SOLICITATION ADDENDUM NO. 1

ITB 19-0013

General Contractor for Montclair Elementary School Classroom Re-Flooring

1. Attachment K – Montclair Floor Plan replaced with Attachment K – Montclair Floor Plan Addendum 1.

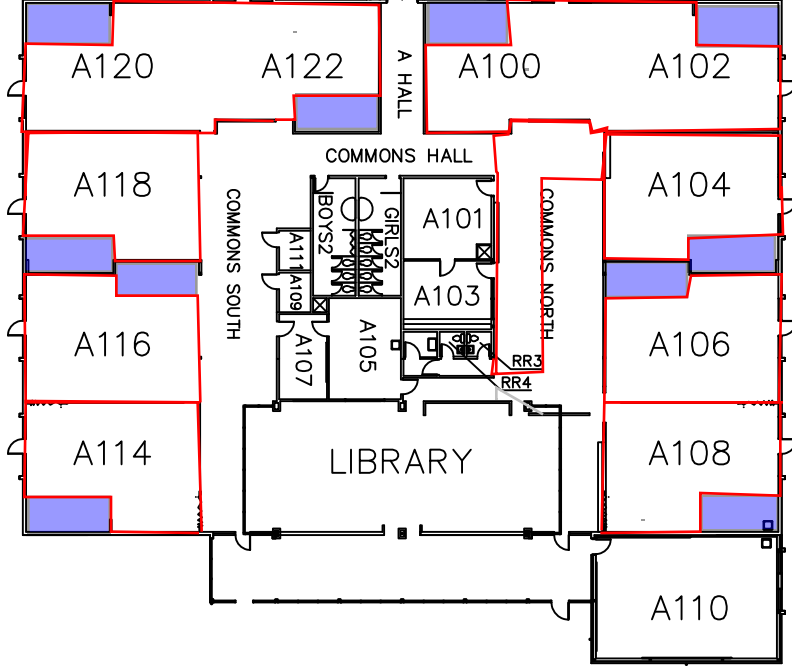
Question: High traffic areas will need a better transition due to the new carpet being thicker than existing due to wear.

Answer: A low profile rubber or vinyl transition strip may be used where new carpet meets existing carpet. Please note the site map has been amended to show the transition in the N. Hallway ending at the narrowest point to ensure minimal use of a transition in this high traffic area.
